RE: **Lot 12 Block 5 Volcano Cliffs Unit 19 SAD 228
6615 Cuervo Pl NW
Grading and Drainage Plan
Engineers Stamp Date 2/12/2021 (D10D003J11)
Pad Certification Date 2/12/2021**

DRAINAGE AND TRANSPORTATION INFORMATION SHEET (REV 6/2018)

ENGINEER'S SEAL	LOT 11 BLK 4 U 18 VOLCANO CLIFFS 6615 CUERVO PLACE GRADING AND DRAINAGE PLAN	DRAWN BY DEM
		DATE 2-10-21
DAVID SOULE P.E. #14522	 1608 CENTRAL AVENUE SE SUITE 201 ALBUQUERQUE, NM 87106 (505) 872-9899	LOT 11 BLK 4 U 18 VOLCANO CLIFFS 6615 CUERVO PLACE.DWG SHEET # C1 JOB #

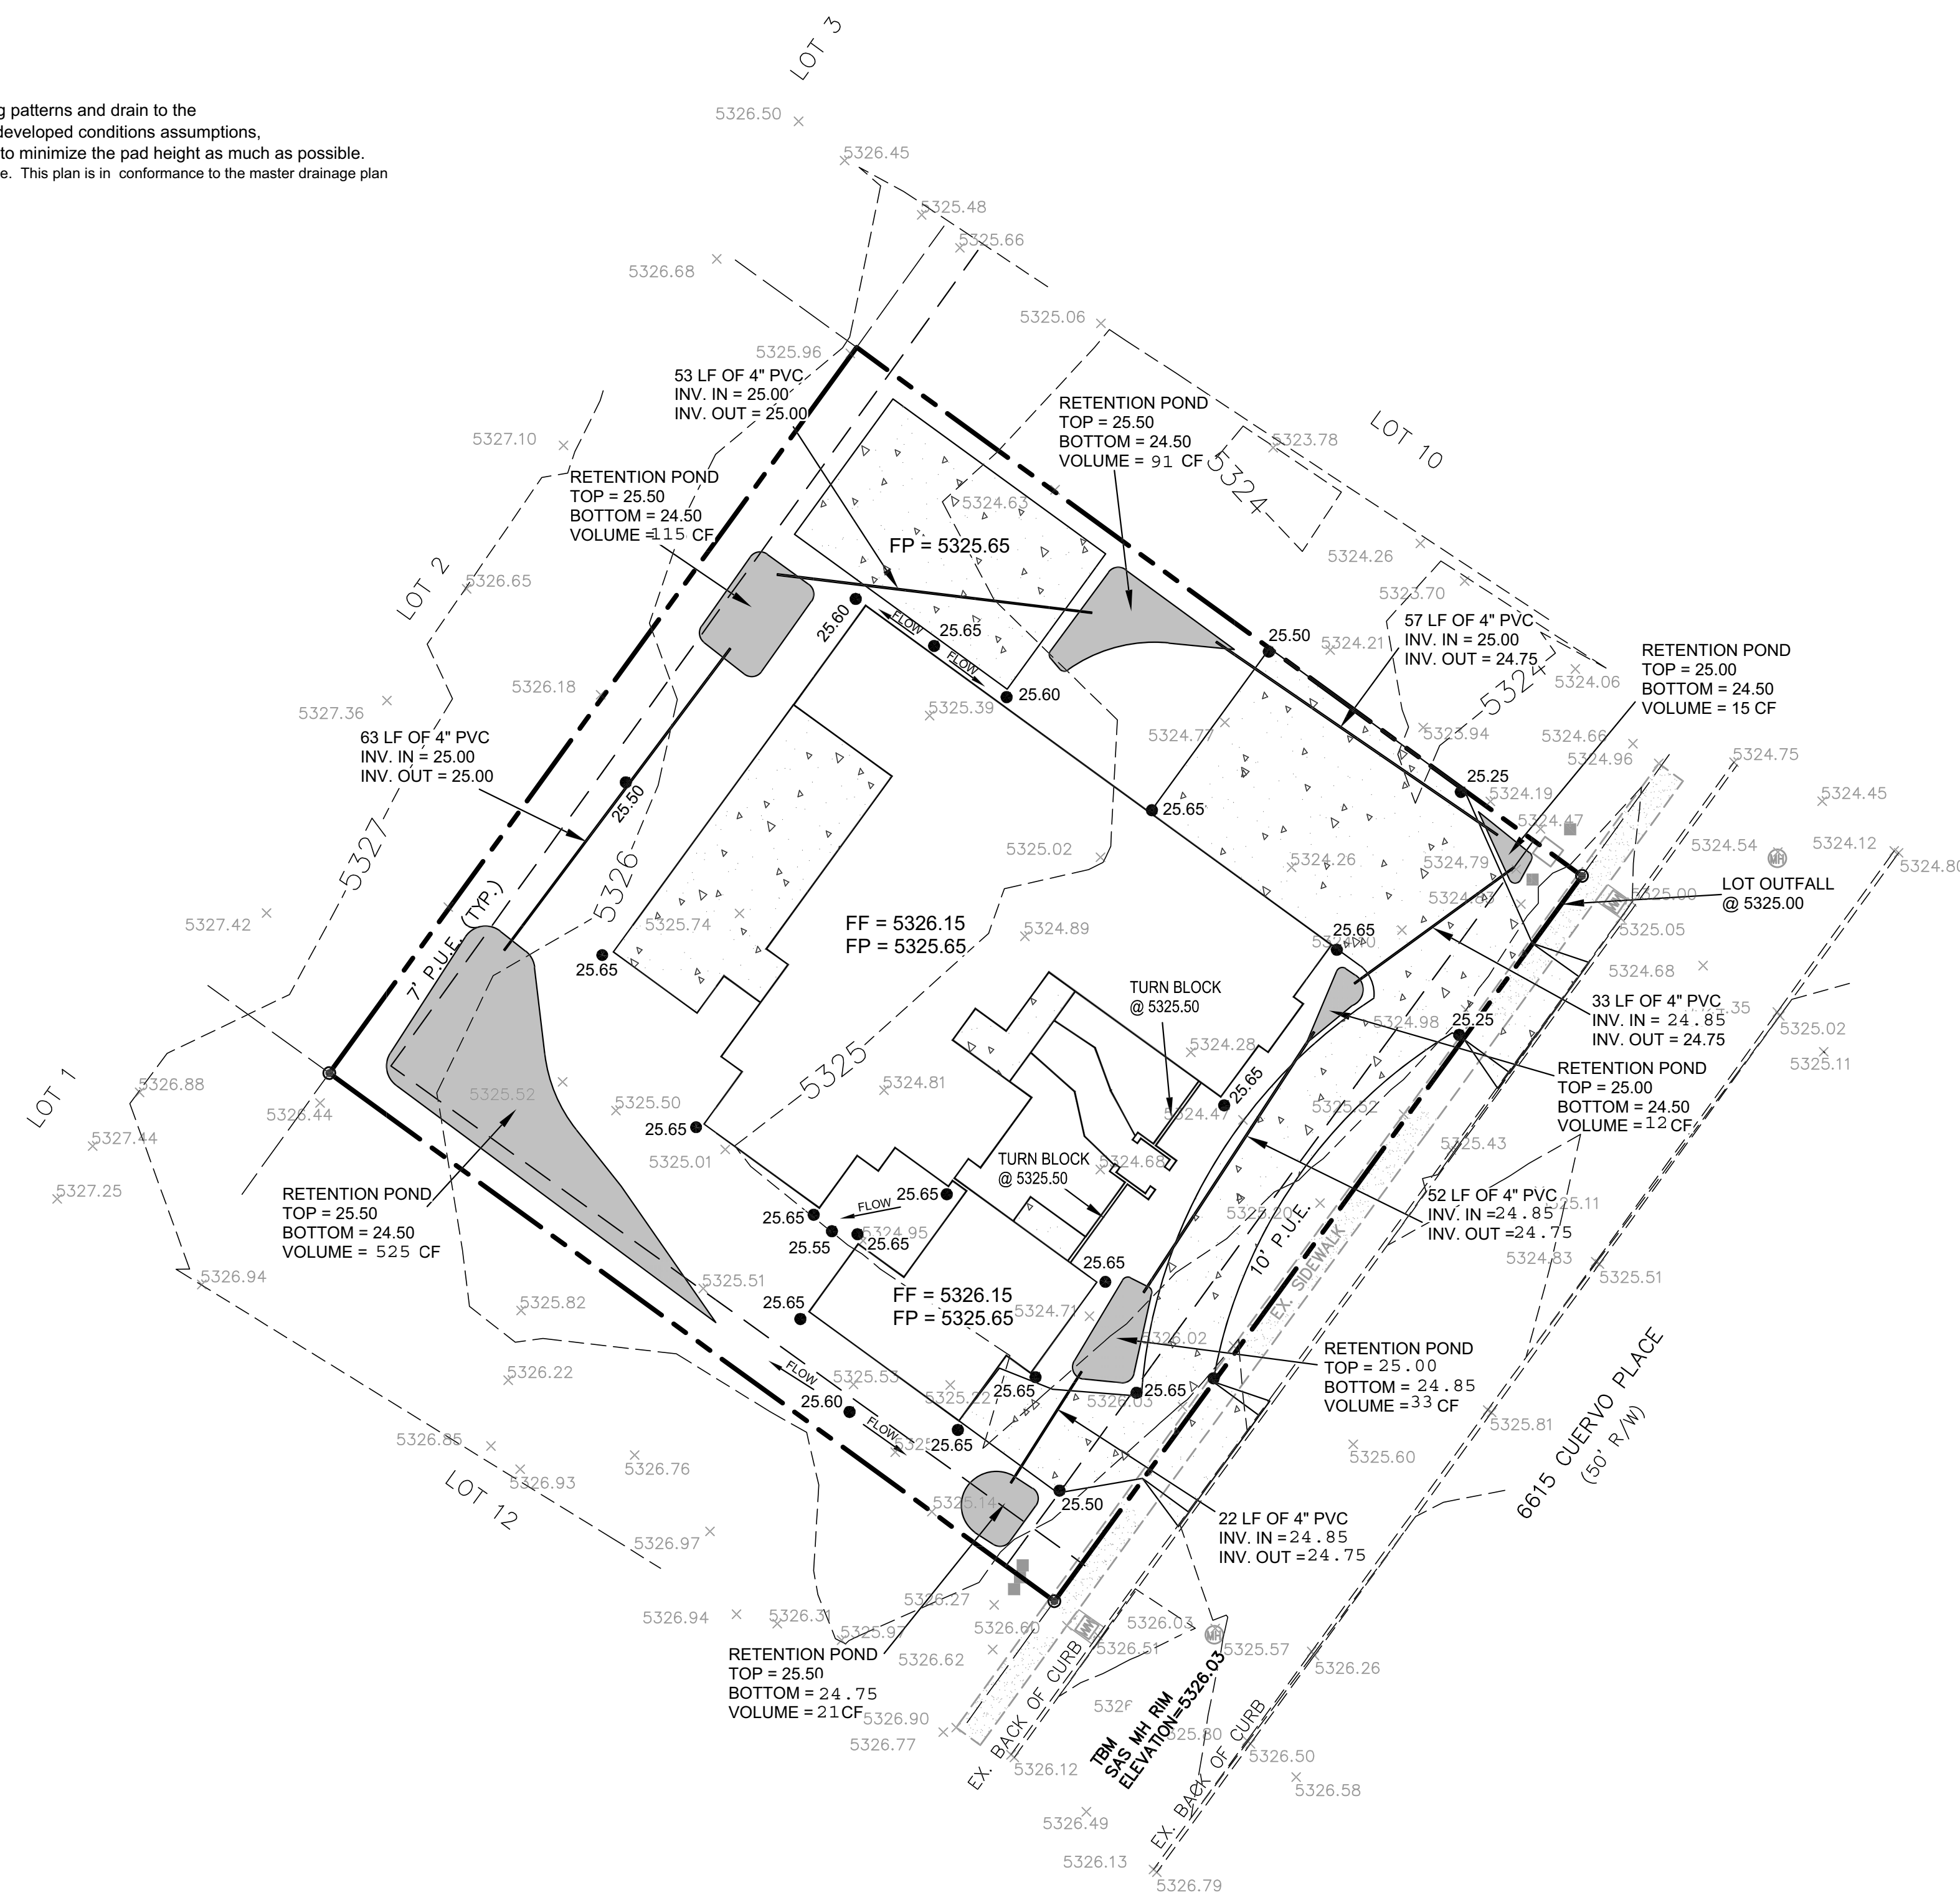
Based upon the information provided in your submittal received 2/15/2021, this plan is approved for Building Permit.

Reiterate to the Owner/Contractor that a separate permit for a garden/retaining wall must be obtained, with the approved G&D plan and Pad Certification. Also, let the owner/contractor know that if a pool is to be added in the future the G&D plan will need to be modified showing the location of the pool and the land treatment differences.

Prior to Certificate of Occupancy release, Engineer Certification per the DPM checklist of this plan will be required.
